PERMIT

SEWAGE DISPOSAL SYSTEM

P 50222
A 16664
A REPAIR

REPAIR - PURPOSE - TO AUTHORIZE HOUSE CONNECTION TO EXISTING SYSTEM.

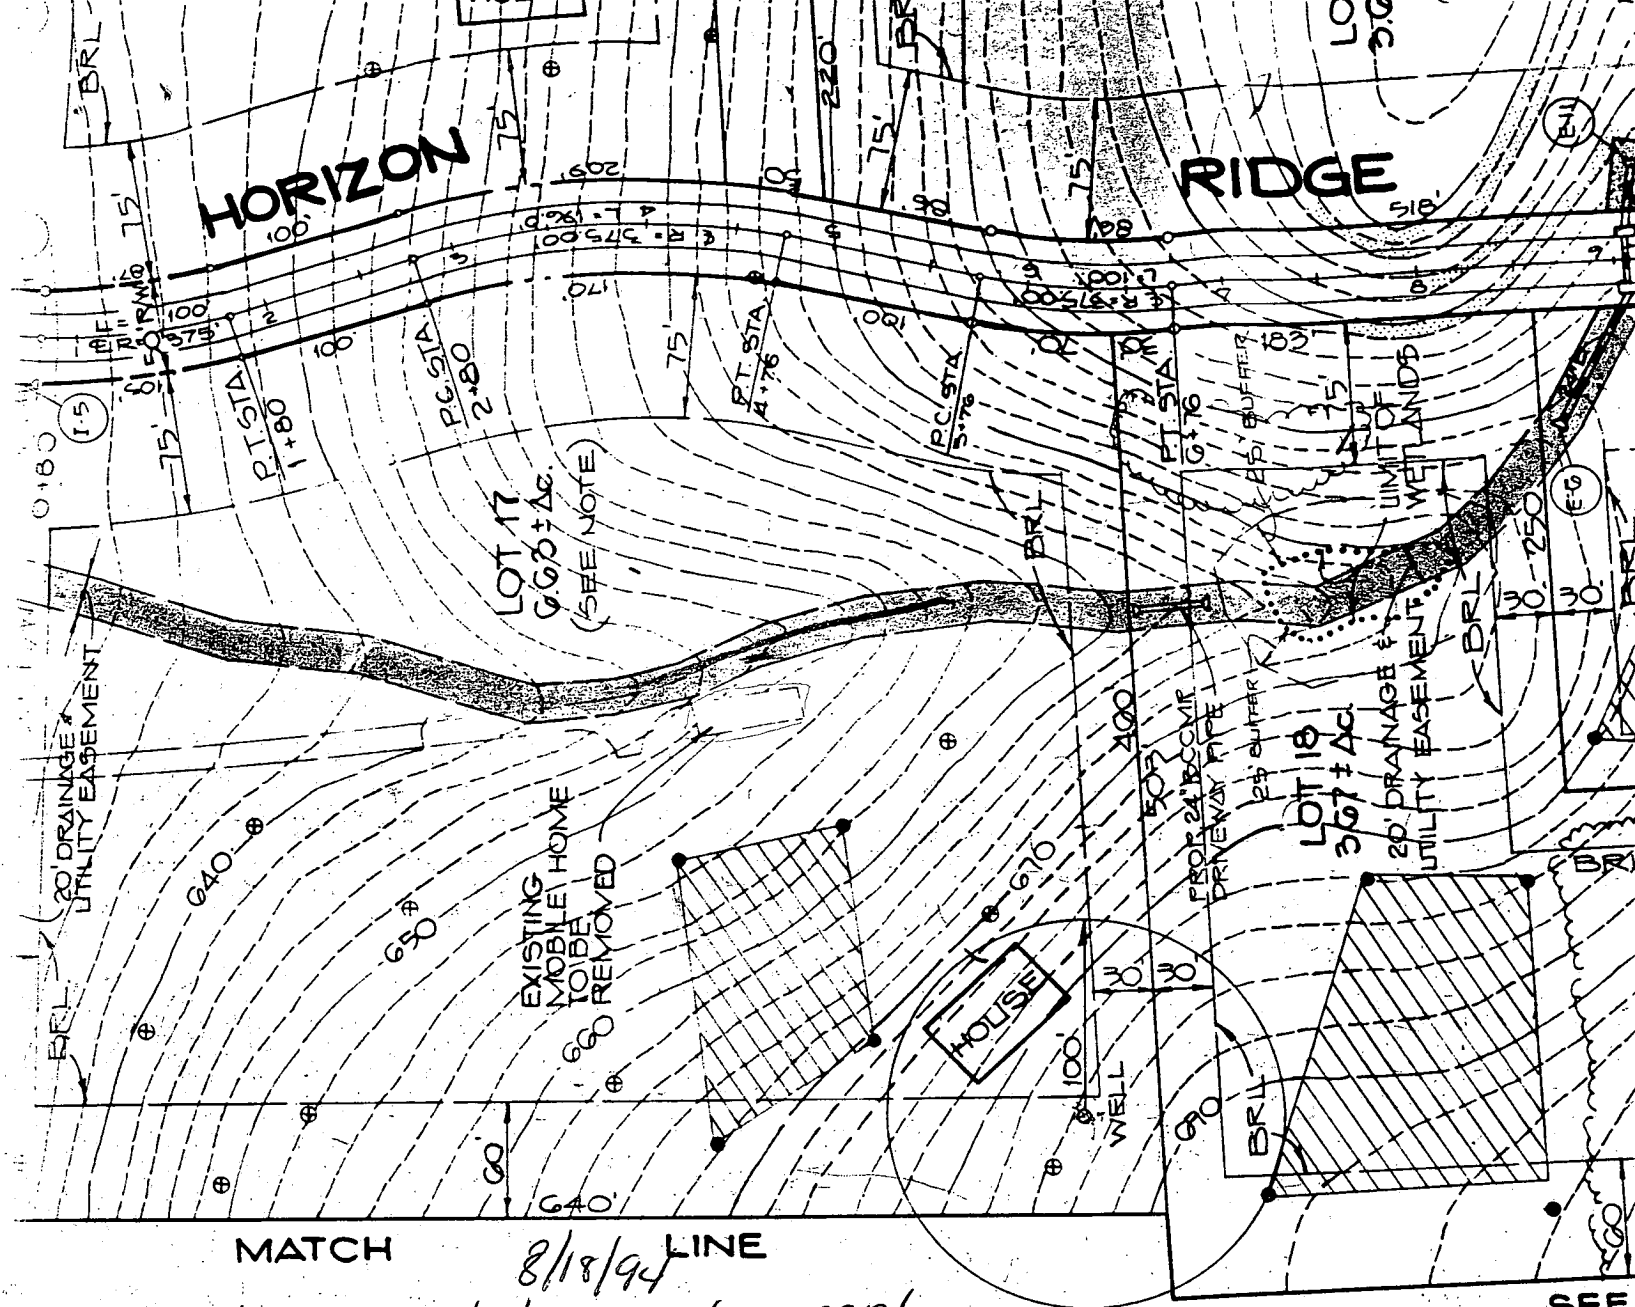
Field inspection for condition of existing septic system

Spoke with owner: ~~that~~ I suggested he get the septic tank pumped prior to u.s.o. The tank probably hasn't been pumped in the 20 yrs since it was initially installed. Tank was half full. New cleanouts were put on the septic tank and immediately outside where the house connection will go

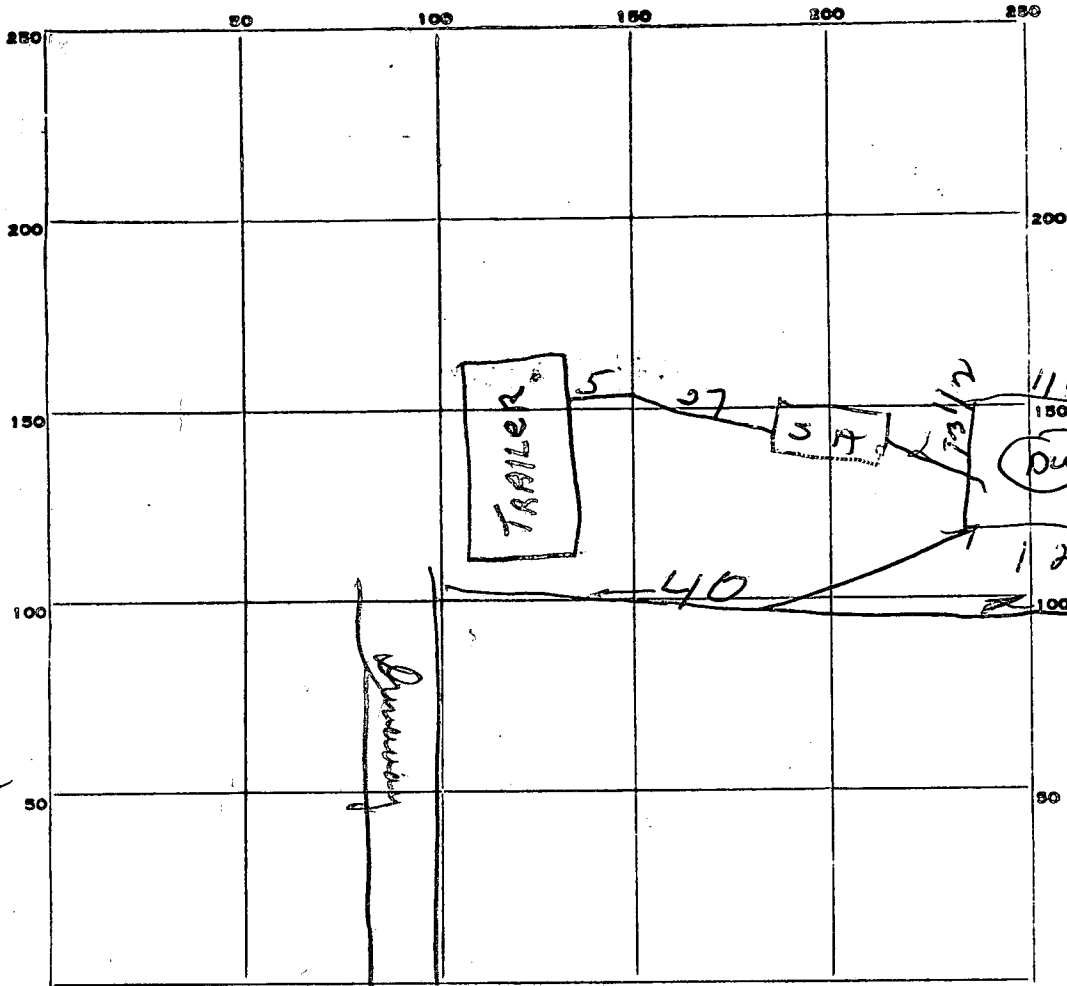
REMARKS 5/19/72 - dy well in wrong location - is only 40 ft from edge of dirt road instead of 75 ft. will need further tests SWM?
